IRON SHIPS.

Survey held at Newcastle Date 10th April to 9th Sept 1863

Ship "Latona" Master J. Mitchell

Planksheer, how secured to the plating of the sides { Explain by sketch }

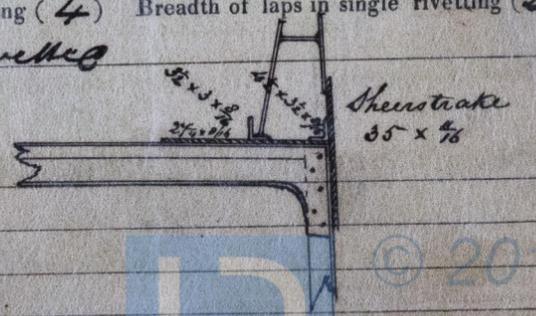
This vessel is a sister ship to the "Aurora" Report No 9097 with which a midship section was sent. There is in this vessel an alteration in the waterways - the same being a gutter one as per sketch.
